### **Project Background**

6-24-2024 REPLY TO 6/24/2024 RFP QUESTIONS #2

BLOCK 118, LOT 29.012

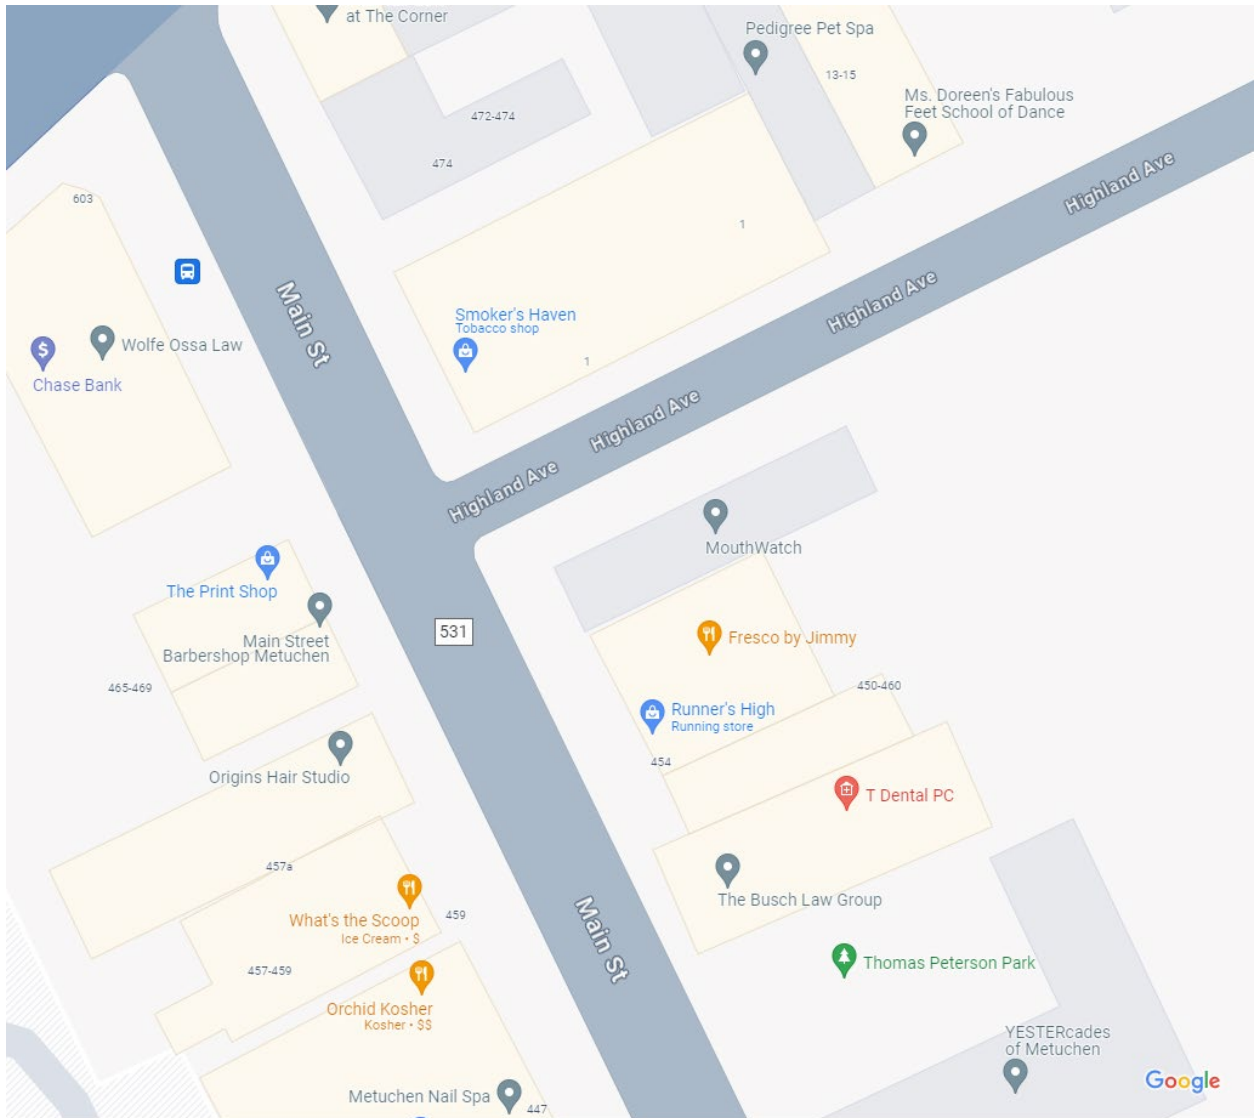
3. If available, please provide a plan or map of what the actual 50' x 100' project area is.
